Hendrix
Late Filed Exhibit
Exhibit No. 30
Analysis of Gillan's Costs
Page 1 of 5

Request: Provide an analysis of the problems with the cost data submitted by Gillan as Late Filed Exhibit 18 (Deposition Exhibit No. 1). Include in your analysis the relevant cost components that should be included but which were omitted as a part of the analysis.

Florida Interoffice Costs

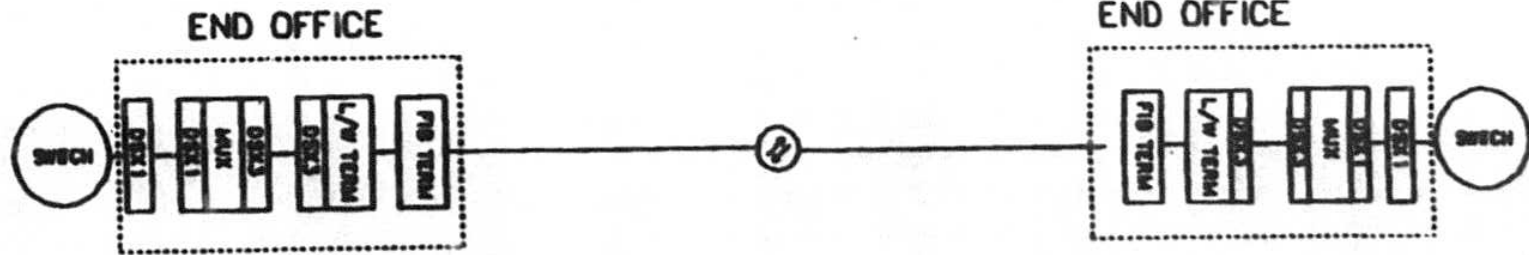
Response: The appropriate fixed costs include the electronics and all equipment on both ends of the circuit. The appropriate per mile costs include the fiber, intermediate central office equipment, any optical regeneration equipment that might be required and relevant fill factors.

If the "cost based" analysis of Mr. Gillan were the appropriate basis for determining the rates for dedicated interoffice transport services, the appropriate Florida interoffice transport costs are shown below:

The above cost were developed by a generic, non-service specific, DS1 and DS3 analysis.

INTEROFFICE FACILITY FIXED INVESTMENT END OFFICES

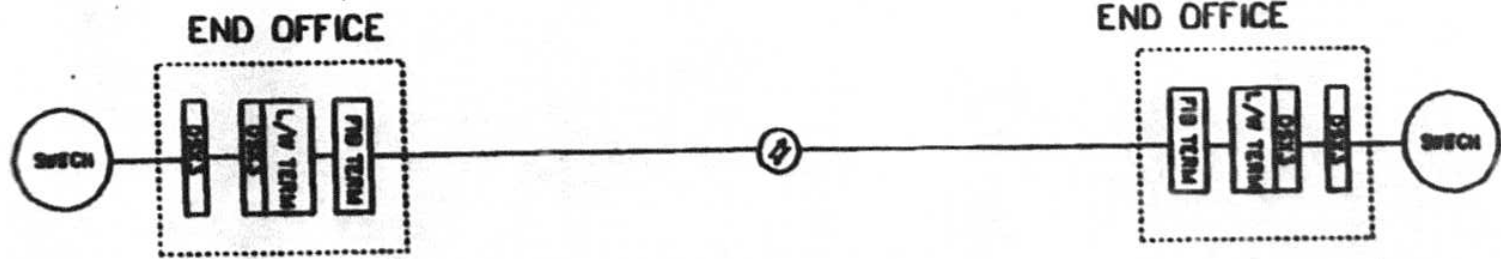
The DS3 costs included in this same exhibit are based on the costs filed by BellSouth in FCC Transmittal No. 53. Transmittal No. 53 restructured LightGate^R 1, 2 and 3 services and introduced LightGate 4 service. Mr. Gillan has used the costs from these filings incorrectly. The calculated Fixed Cost of a DS3 that was included on Exhibit JPG-4 is \$1,061.88. This \$1,061.88 figure inappropriately includes one Central Office Channel Interface (COCI) at \$51.18. The COCI per 28 DS1 Channel System cost already includes the COCI-DS3 and does not need to be included again. Additionally, the \$1,061.88 figure excludes one end of the COCI DS1. The Fixed Cost of a DS3 should include the "average" fixed, 2 COCI per 28 DS1 Channel Systems and 56 COCI per DS1 which appropriately multiplexes the DS1s at both ends of the circuit. The diagrams on pages 3 of 4 and 4 of 4 of this exhibit contain the different elements for DS1 and DS3 services.
